October 17, 2005

**SUBJECT:** Response to Request for Additional Information dated October 7, 2005  
Sumter Cement – Center Hill Plant  
DEP File No. 1190041-001-AC (PSD-FL-358)  
Proposed Portland Cement Plant in Sumter County, Florida

Chart 1: CO with Bauxite and Fly Ash Use at SAC

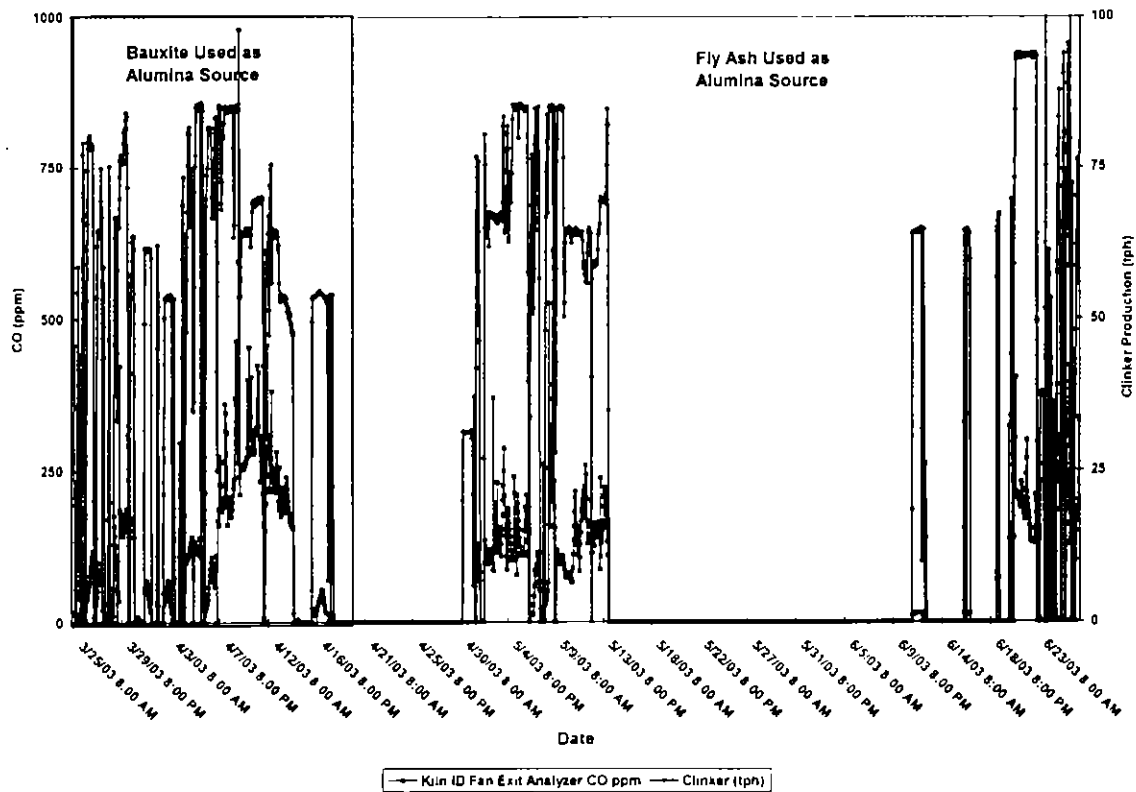
- a. Given the present calciner design, estimate the CO emissions when using bauxite instead of fly ash as a raw material and only coal as fuel (except during startup).

Based on data from SAC, which actually ran with bauxite for several months prior to using fly ash, SCC determined minimal impact to CO emission from the use of bauxite versus fly ash. Chart 1 shows the CO as measured by a process analyzer for CO located in the downcomer after formation of CO from raw materials. It can be seen that during the limited time frame of bauxite use, the CO emissions appear comparable to the use of fly ash.

As stated previously, provisions for the injection of fly ash into the calciner will be included in the SCC project as a means to insure proper combustion of fly ash with higher carbon content instead of gradual heating through the tower. The data from SAC with use of bauxite as well as Fly Ash Injection were used to develop the baseline CO emissions for SCC at 3.6 lb per ton of clinker.

Chart 2: SAC SO<sub>2</sub> Emission Data 2005

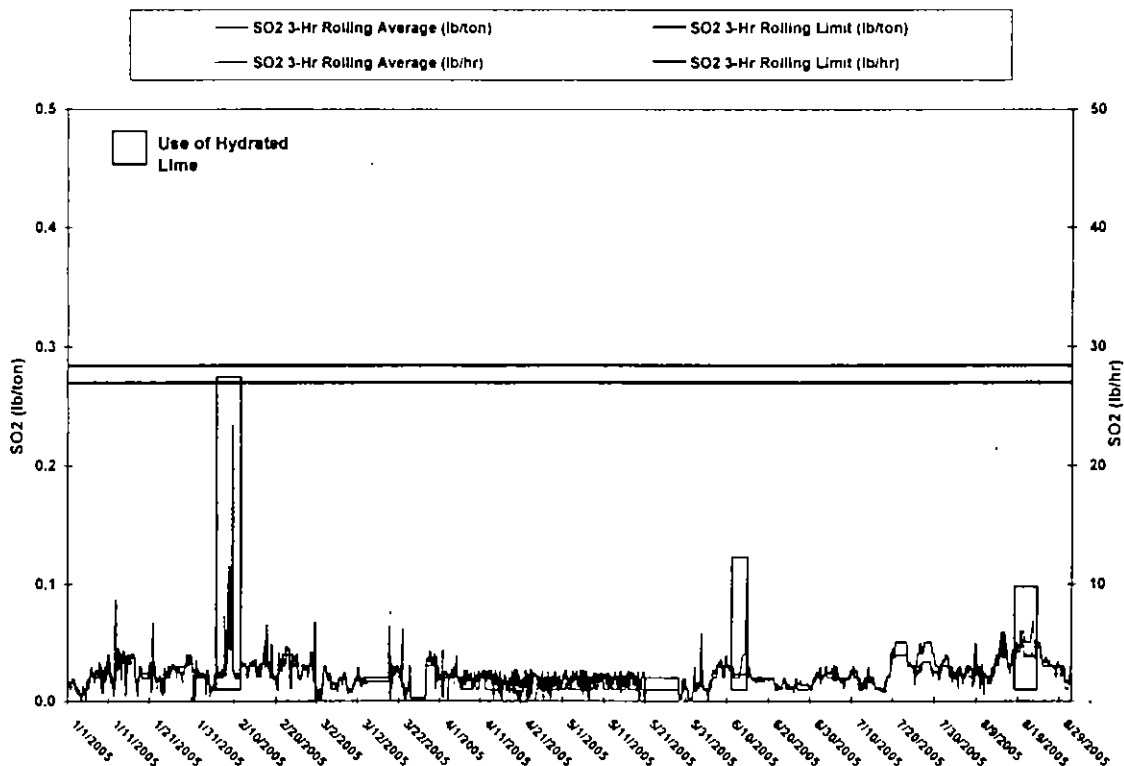
4. Please provide a disk that includes a summary of 2005 data for 24-hr-averaged SO<sub>2</sub> emissions in terms of lb/ton from operation of the SAC plant. Indicate instances when injection of hydrated lime was practiced and the total amount of hydrated lime actually used for this purpose in 2005 [Rule 62-212.400(h)3., F.A.C.]

SAC closely monitors the sulfur inputs, but due to limited alkali the smallest shift in sulfur in limestone can cause the balance to be lost and excess sulfur to circulate in the raw mill/kiln system. SCC proposed to install the hydrated lime system as SAC has done as a means to insure compliance with the extremely low SO<sub>2</sub> limit. The use of the system would be very limited, with control of sulfur inputs being the means to insure long term compliance.

Chart 2 shows the SO<sub>2</sub> emission data for SAC for 2005.

Figure 1: SCC Proposed Quarry Area

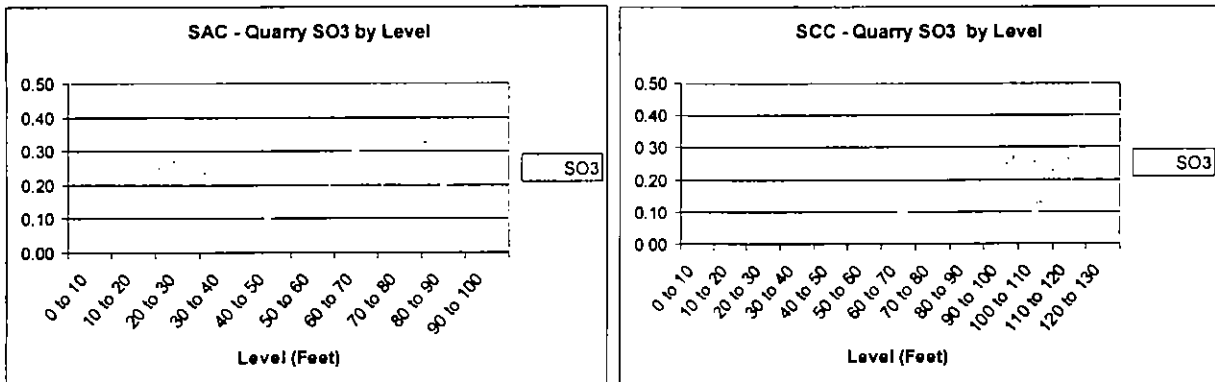
7. *Provide a qualitative if not quantitative discussion of the differences in sulfur and SO<sub>2</sub> generation potential due to raw materials differences between the quarries at SAC and SCC. [Rule 62-212.400(h)3., F.A.C.]*

For SCC, the results of the quarry survey revealed that in areas where the limestone was present very little sulfur was detected. Some areas which did not present high concentrations of limestone contained sulfur levels similar to those found at SAC, which is predominately pyritic sulfur. SCC has designed its quarry around these areas as shown in the following Figure.

Analysis of the coring conducted in the proposed quarrying area were similar or lower in  $SO_3$  (oxide of sulfur detected by X-Ray Diffraction) than SAC. The following charts show the relation at the varying depths between SAC and SCC.

SCC Road Segment and Emission Parameter Table

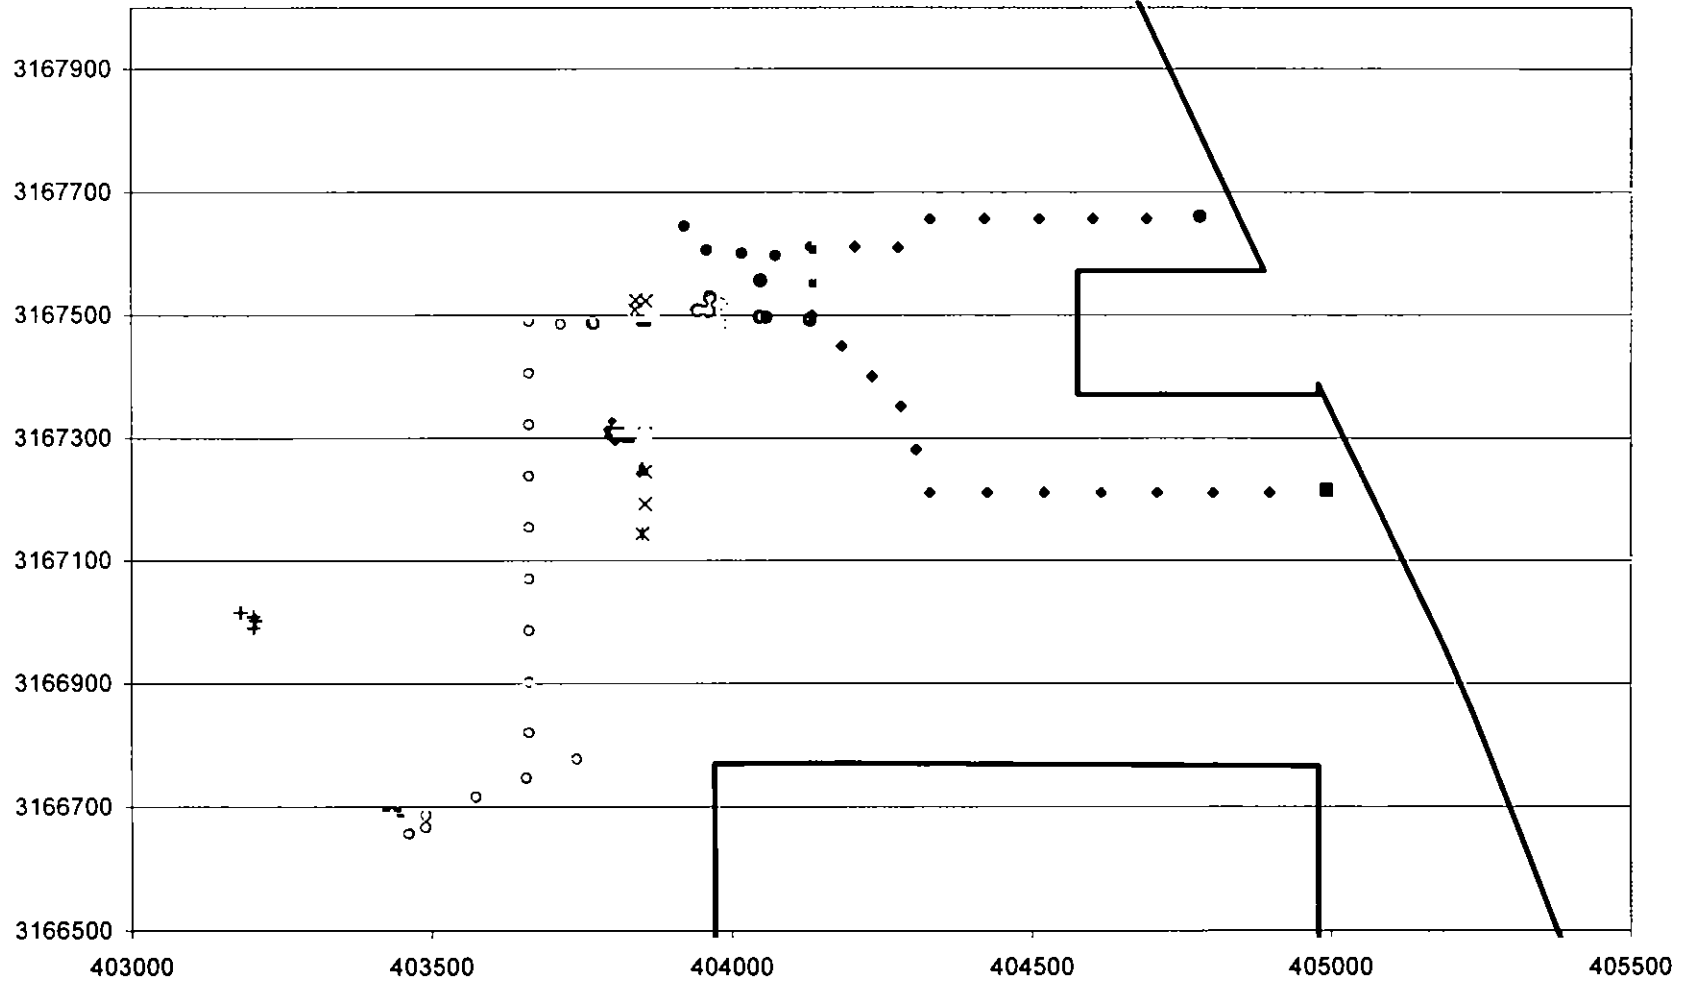
23. *Please provide a diagram showing each road segment, its location and its emission parameters.*
